Access Compliance Report Public Rights-of-Way (Curb Ramps)

Main Street: LA LIMONAR_RD Cross Street: ARROYO_AVE Location: NE

ADA ID: RPRK211013124916 Ramp Type: Type 1 - Perpendicular Diagonal Initial Pass/Fail: Fail Overall Compliance: No Severity Score: 2

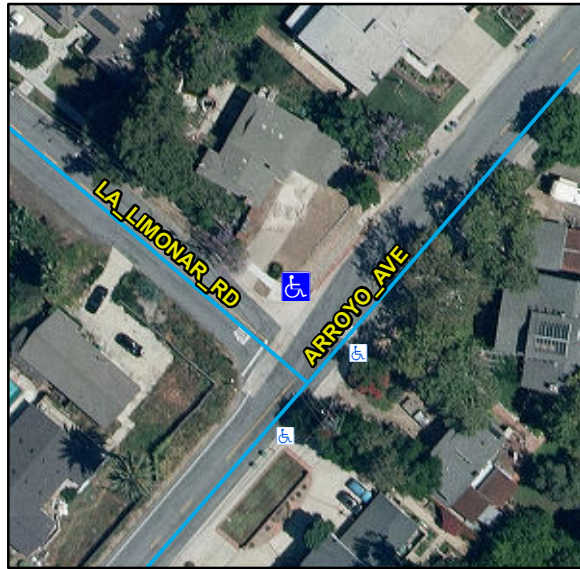
Compliance	Description	Data	Compliance	Description	Data
N/A	Ramp Length (in)	90	N/A	Flare Type LT	
Yes	Ramp Width (in)	48			N/A
Yes	Ramp Run Slope (%)	4.3	N/A	Flare Slope LT (%)	N/A
No	Ramp Cross Slope (%)	2.2	N/A	Flare Traversable LT	N/A
N/A	Landing Present	N/A	N/A	Flare Type RT	
N/A	Landing Length (in)	N/A			N/A
N/A	Landing Width (in)	N/A	N/A	Flare Slope RT (%)	N/A
N/A	Landing Run Slope (%)	N/A	N/A	Flare Traversable RT	N/A
N/A	Landing Cross Slope (%)	N/A	N/A	DWS Provided	N/A
N/A	Landing Movement Obstructed?	N/A	N/A	DWS Contrast	N/A
	Landing Movement Type	N/A	N/A	DWS Length (in)	N/A
N/A	Landing Shared	N/A	N/A	DWS Full Width	N/A
N/A	Clear Space	Yes	N/A	DWS Offset Left (in)	N/A
N/A	Clear Space To Crosswalk (in)	N/A	N/A	DWS Offset Right (in)	N/A
N/A	Marked Crosswalk 1	No	N/A	Marked Crosswalk 2	No
	Crossing 1 Direction	SW		Crossing 2 Direction	SE
	Marked Crosswalk 1 Width (in)	N/A		Marked Crosswalk 2 Width (in)	N/A

N/A	Ramp Inside Crosswalk 1	N/A	Yes	Ramp Inside Crosswalk 2	N/A
	Crossing 1 Slope (%)	1.4		Crossing 2 Slope (%)	3.9
	Crossing 1 Cross Slope (%)	1.9		Crossing 2 Cross Slope (%)	4
N/A	Gutter Ponding	N/A	N/A	Curb Slope	3.2
Yes	Gutter Lip Height (in)	0		Road Run Slope (%)	0
N/A	Gutter Run Slope (%)	N/A		Road Cross Slope (%)	2.9
N/A	Gutter Cross Slope (%)	N/A			
Yes	Overall Surface Condition: Acceptable		Yes	Perp Joint Present	Yes
	Cross Gutter Present?	Yes		Spandrel Present?	Yes
	Replace Cross Gutter?	No		Replace Spandrel?	No

Remove & Replace Curb Ramp With Two New Directional Ramps or Equivalent.

R304.5.3, STD 1115
